JERSEY CENTRAL POWER & LIGHT COMPANY
OYSTER CREEK NUCLLAR GENERATING STATION

Technical Specification
Change Request No. 80
Docket No. 50-219

Applicant submits, by this Technical Specification Change Request No. 80 to the Oyster Creek Nuclear Generating Station Technical Specifications, changes to Specification 3.5.A.9.

FIGURE 3.5-1

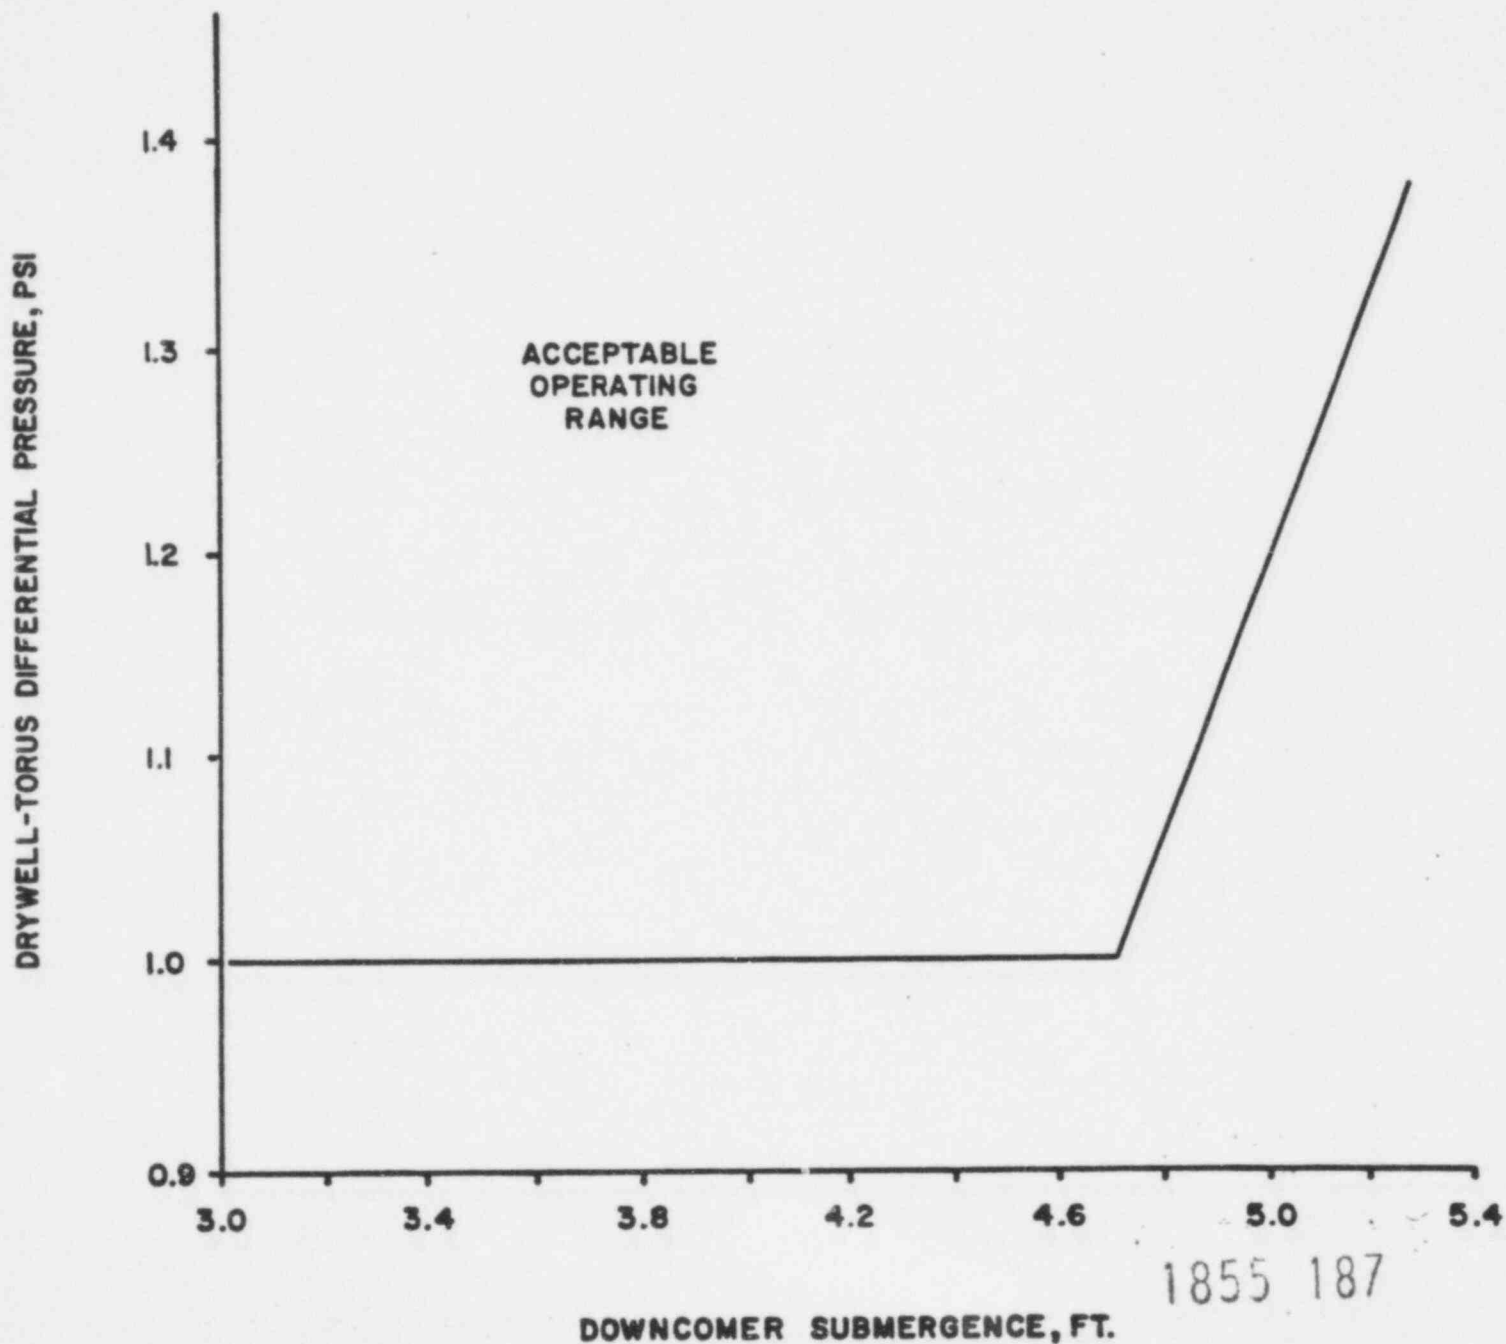
Revise the above section such that a suppression chamber downcomer submergence range of 3.0 to 5.3 feet is acceptable.

In order to mitigate the pool swell loads in the torus as a result of a LOCA, the downcomers in the torus shall be truncated such that there is a three foot submergence below the minimum allowable suppression pool water level. General Electric's Report NEDE-21885-P presents the technical basis for the use of three feet minimum downcomer submergence in Mark I plants, via truncation of the existing downcomer length, and indicates that such a modification will not prevent the containment from performing its intended safety function.

*The actual acceptable range of downcomer submergence is governed by the Technical Specifications limit on maximum and minimum water volume in the torus (see section 3.5.A.1). This actual acceptable range of downcomer submergence will not encompass the full range of downcomer submergence indicated in the figure above.
